DATE: May 19, 2025
TO: Desirae Lujan – Senior Planner
THROUGH: Eric Martinez, P.E., C.F.M. – Public Works Director 
FROM: Eric Ulibarri, P.E. – County Engineer
CC: Danyelle Valdez – Planning Manager
RE: Arbolada Subdivision Preliminary Plat Application (A Replat of Tract D) – Public Works/Engineering Comments

Preliminary Plat

Case No. **SUB-2025-0021**. Consensus Planning and Titan Development.

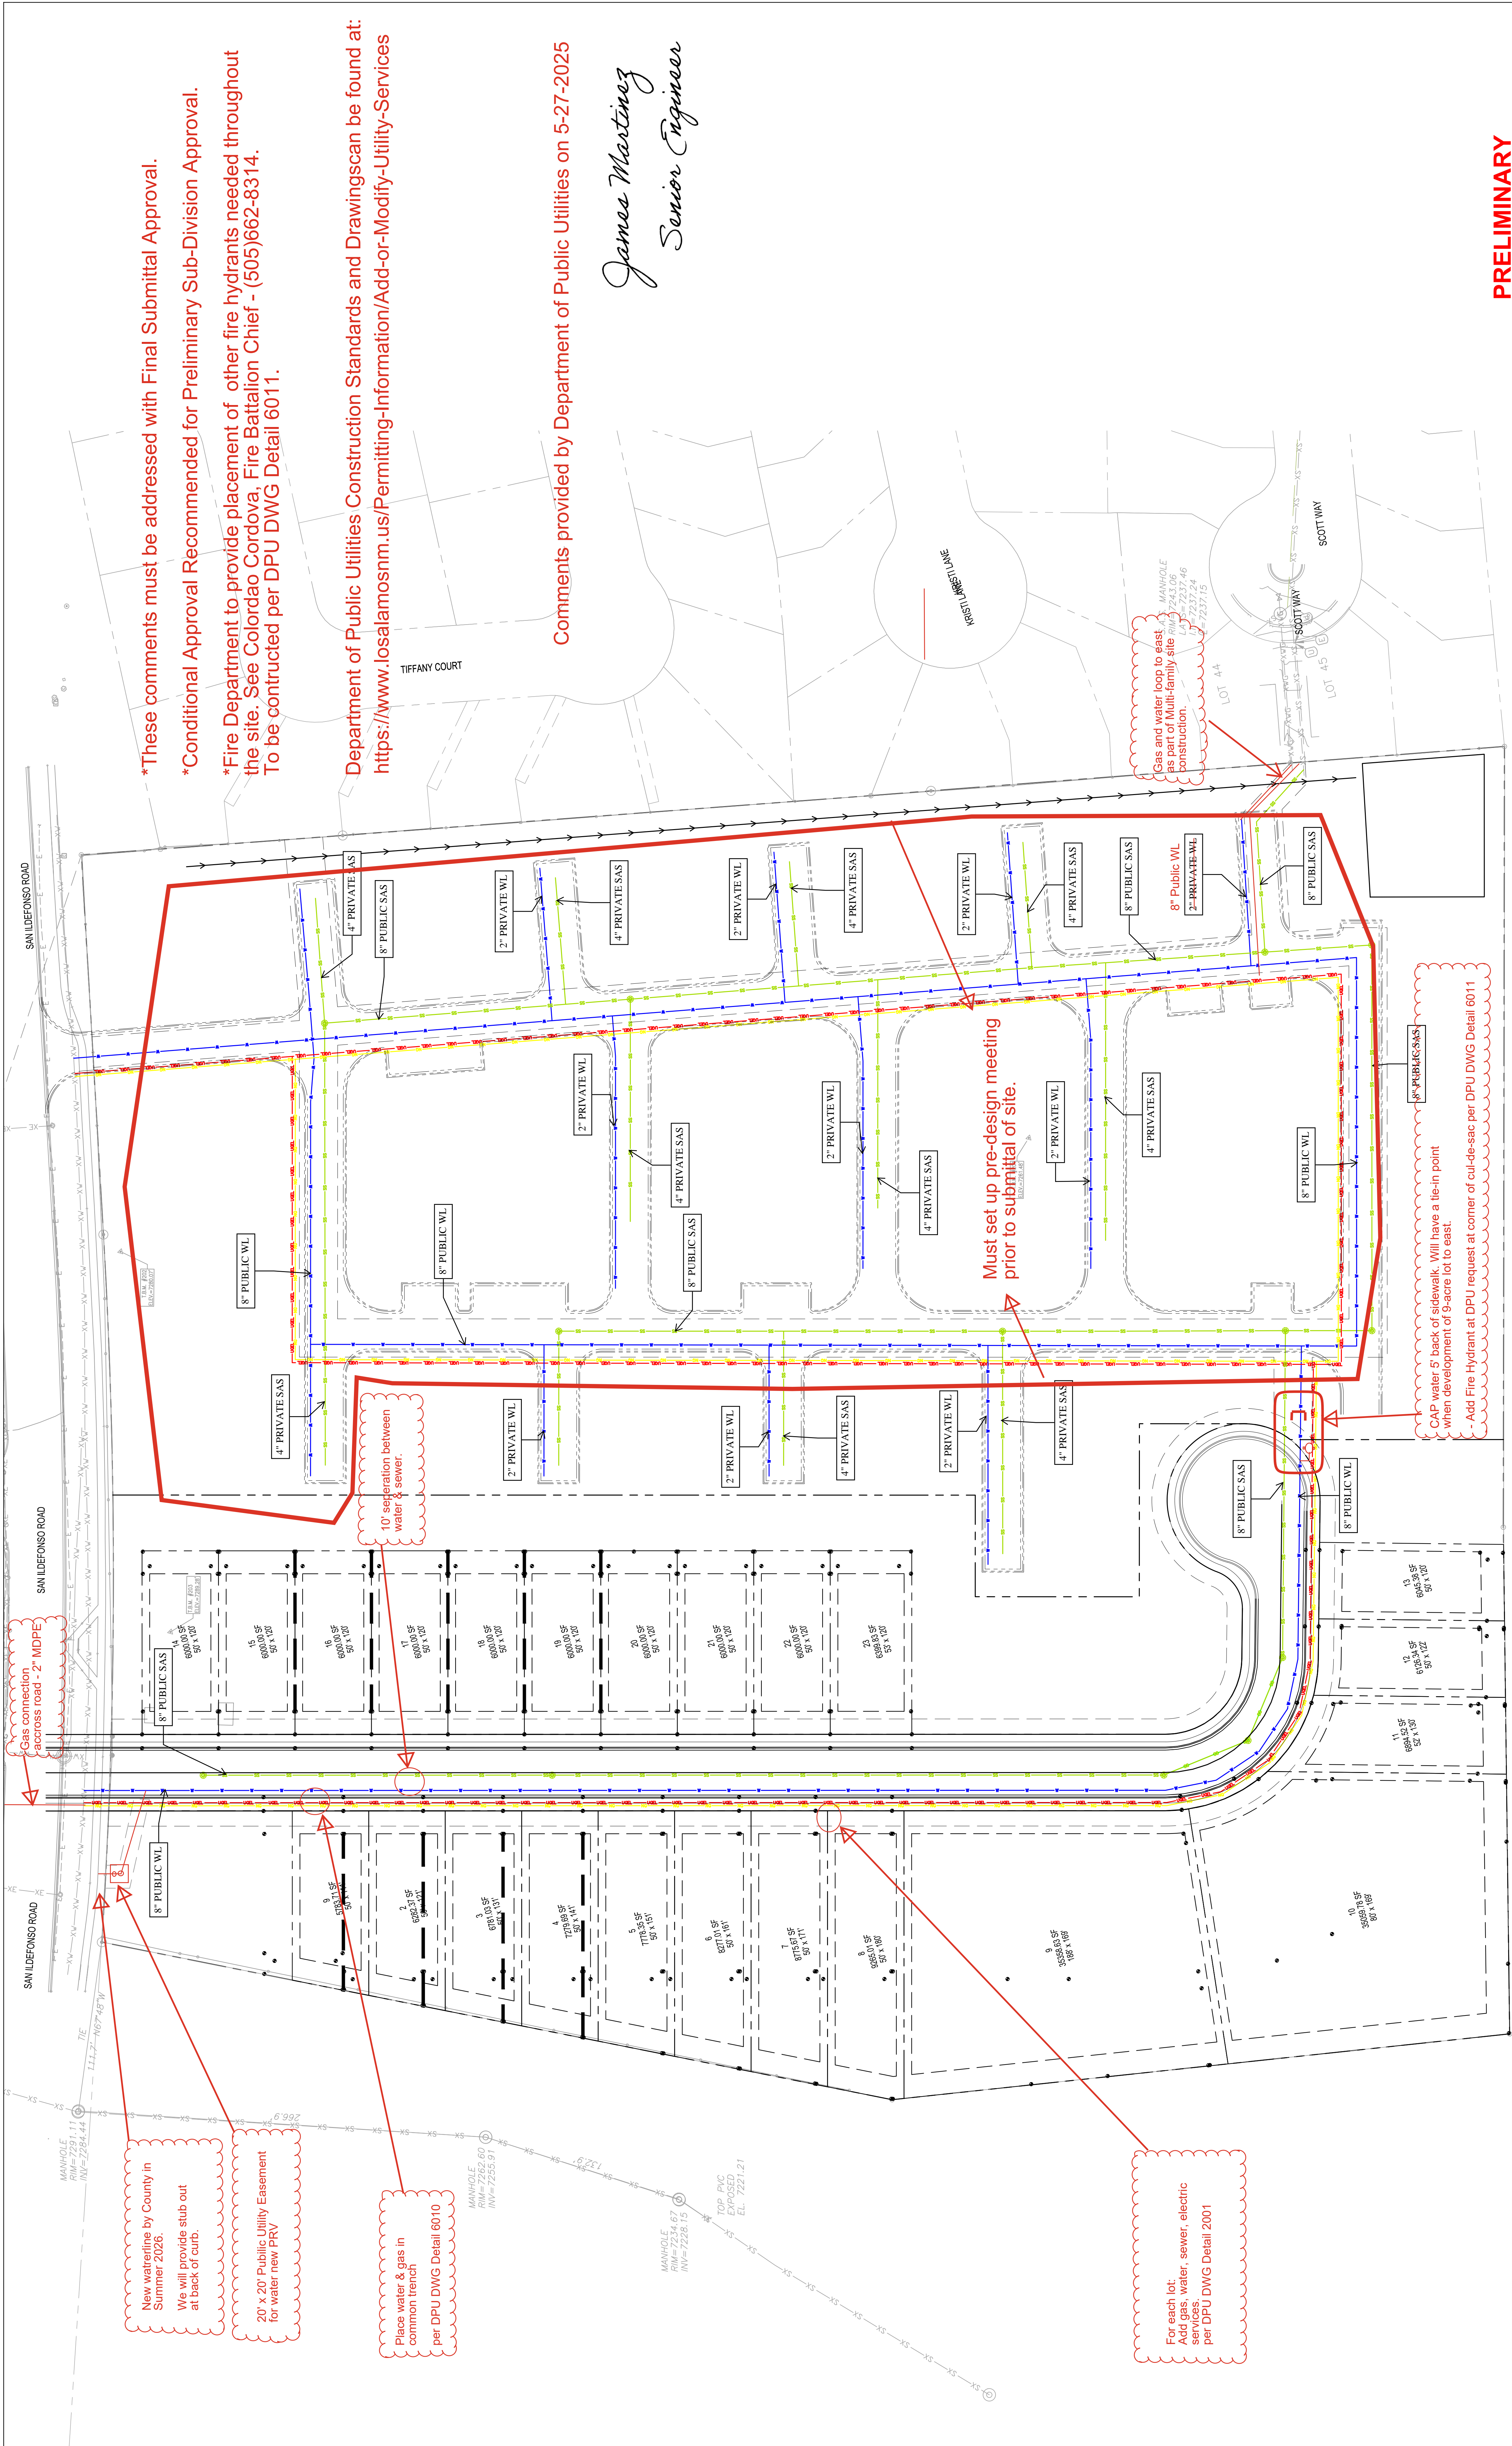
- The applicant has indicated in the Preliminary Plat that Tracts 1, 2 and 3 are being created for permanent open space and drainage easements. No features within these tracts will be accepted for County dedication and maintenance without prior approval.

- Lighting: The intersections on San Ildefonso Road shall be analyzed to determine street lighting needs. Additional street lighting may be required, or existing streetlights may need to be removed and relocated to better serve the intersections and enhance safety.

- Traffic Analysis: A traffic analysis shall be performed with a report submitted prior to submission of the Final Plat and Site Plan. The site plan proposes two access points to the development site from San Ildefonso Road and shall be evaluated to preferably align with the opposing driveways that serve the Mesa del Norte and Mountain Vista Apartments on the north side to mitigate traffic safety conflicts.

- Bus Pullouts: Location of a bus pullout along the south side of San Ildefonso Road shall be provided.
- The radius of the cul-de-sac should meet the requirements of the fire code in coordination with the Fire Marshal.

- Drainage Report: A drainage analysis shall be performed with a report submitted prior to submission of the Final Plat and Site Plan.
- Department of Energy Review and Coordination

- As this subdivision will result in changes in site runoff into the adjacent canyon, the DOE must be given opportunity to review and provide comments to the site plan.

The Applicant through their design professionals shall address the comments submitted by the Public Works Department prior to submission of the Final Plat and Site Plan.

FIGURE D103.1
DEAD-END FIRE APPARATUS ACCESS ROAD TURNAROUND

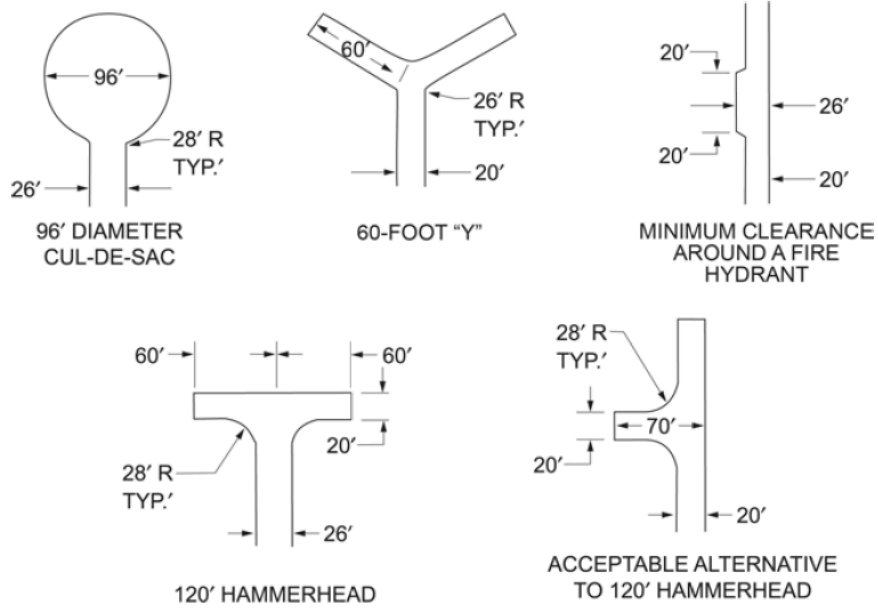
Cul-de-sac size

Below is the minimum cul-de-sac size required based on length of access road. This is taken from the IFC 2021.

D103.1 Access road width with a hydrant. Where a fire hydrant is located on a fire apparatus access road, the minimum road width shall be 26 feet (7925 mm), exclusive of shoulders (see Figure D103.1).

D103.4 Dead ends. Dead-end fire apparatus access roads in excess of 150 feet (45 720 mm) shall be provided with width and turnaround provisions in accordance with Table D103.4.

LENGTH (feet)	WIDTH (feet)	TURNAROUNDS REQUIRED
0–150	20	None required
151–500	20	120-foot Hammerhead, 60-foot "Y" or 96-foot-diameter cul-de-sac in accordance with Figure D103.1
501–750	26	120-foot Hammerhead, 60-foot "Y" or 96-foot-diameter cul-de-sac in accordance with Figure D103.1
Over 750		Special approval required
